RE: Works under the dripline of T026

As per your November 10, email request regarding proposed and previously undertaken works at number 17C Melrose Street within the dripline of T026.

The works relate to Planning Application LUC-2020-546. The schedule tree T026 is described in the 2GP tree list (Appendix A1.3) as a Wellingtonia (*Sequoia sempervirens*) and shown as growing on number 47 Garfield Avenue.

Image one: Image of T026 showing the approximate location the relative drip lines / tree protection zones

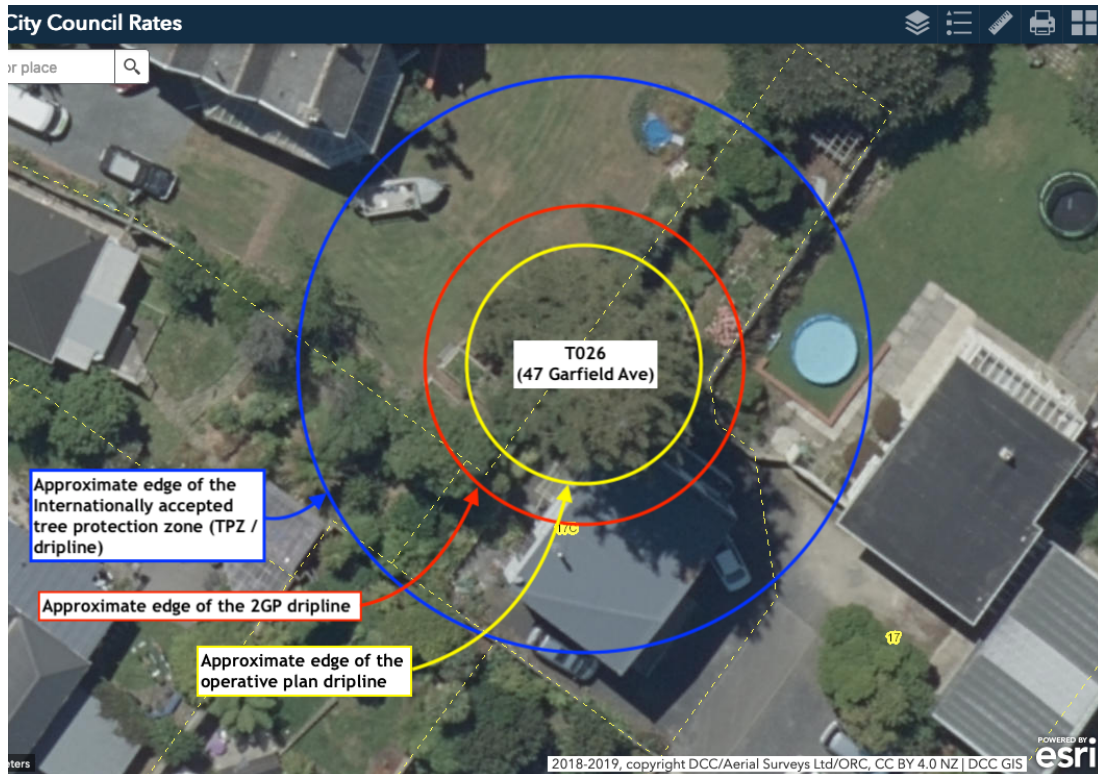
At the October 19 site visit works had already been undertaken, including post hole boring and the removal of at least 40cm soil on the 17C Melrose Street side of the dripline (image three). The soil removal works involved lowering the existing ground level along the boundary line between numbers 17C Melrose St and 47 Garfield Ave, with the excavation basically running parallel to and about 1m from the boundary fence (image four).

- 2.1 Based on the depth and proximity of the cut (soil excavation) to T026, I estimated that approximately 40% of all roots have been removed, including up to 30% of the structural roots.
 - 2.2 According to international standards, an incursion of more than 10% into the tree protection zone is considered a major incursion, and no works should take place inside the structural root zone
3. There were a number of fence post-holes dug and left open – these holes had no fence posts in them at the time

5. No further excavation or soil removal shall take place within the 2GP dripline of T026 (*see image one*)
6. All existing 'open' fence post holes shall be backfilled with top-soil - fence posts shall not be placed in these holes and no additional holes shall be dug within the 2GP dripline of T026

Image five: Copy of the applicant's 02/11/20 Site Plan attached as page 9 of application LUC-2020-546

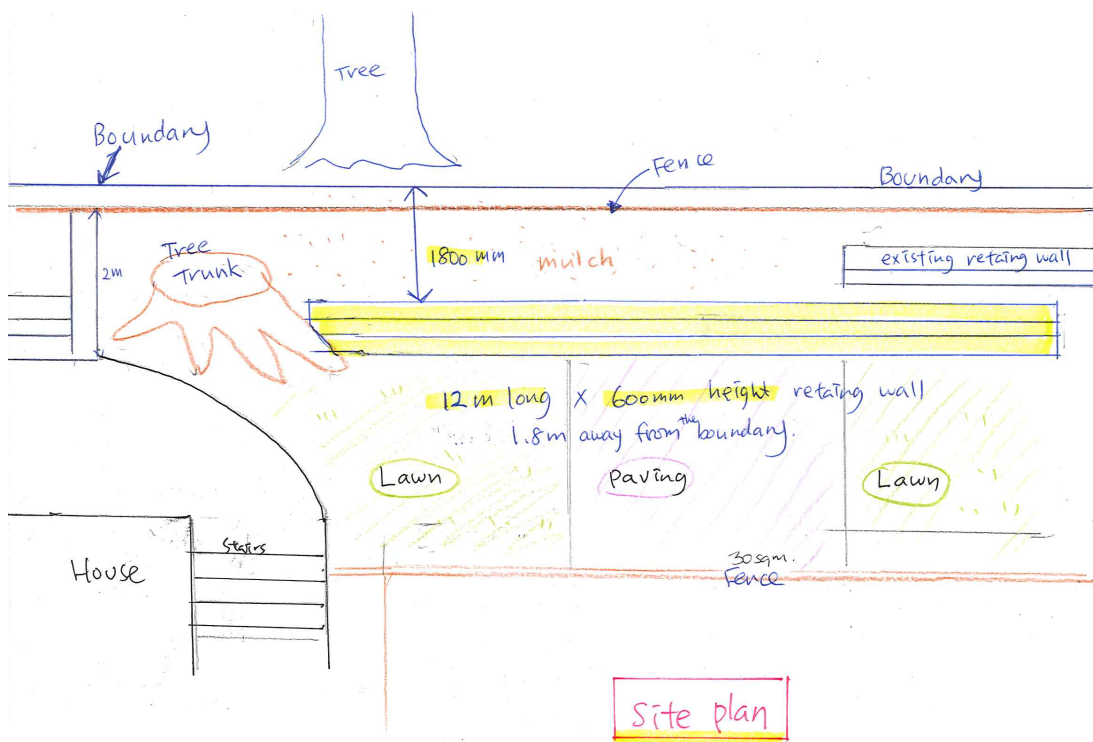
- *a retrospective resource consent application for Works within the dripline of significant tree T026*
4. Application LUC-2020-546 contains a hand-drawn Site Plan which may or may not be to scale (image five). It shows a 0.6 x 12m long proposed retaining wall running 1.8m from the boundary. It shows a stump that does not appear in the photos taken on October 19 and indicates that the fence is built inside the boundary by an unspecified distance.

7. A 600mm tall retaining wall shall be erected no closer than 1.8m from the fence line (*as per image six*).
 - 7.1 During construction of this wall, no materials or equipment shall be placed or stored on the soil currently over the roots of T026

8. The retaining wall shall extend from the side of the raised garden bed (*as shown in image five and indicated in image six*) and run parallel to the fence extending to beyond the outside edge of the 2GP dripline of T026

9. Once the retaining wall has been constructed, topsoil shall be added along the entire length of the retained area (between the retaining wall and cut surface of the roots/newly exposed bank) to a depth of approximately 500mm. On top of the topsoil, a layer of wood-chip mulch at least 100mm deep shall be applied to form a mulch cover from the edge of the retaining wall to the edge of the fence along the full length of the retained area (*image six*)

- 13.1 The irrigation shall involve a commercially available soak-hose [i.e. a soaker or weeper hose or equivalent] attached to and run off the domestic water supply. The soak-hose is to run the full length of the retained area and be positioned as close as practical to the base of the fence (*image six*)

- The tree T026
- The 'fence'
- The boundary line
- The existing raised garden bed
- The position of the proposed 600mm tall retaining wall (*NB: 1.8m from the fence not 1.8m from the boundary as shown in image five*)
- The retained area
- The location of the irrigation hose
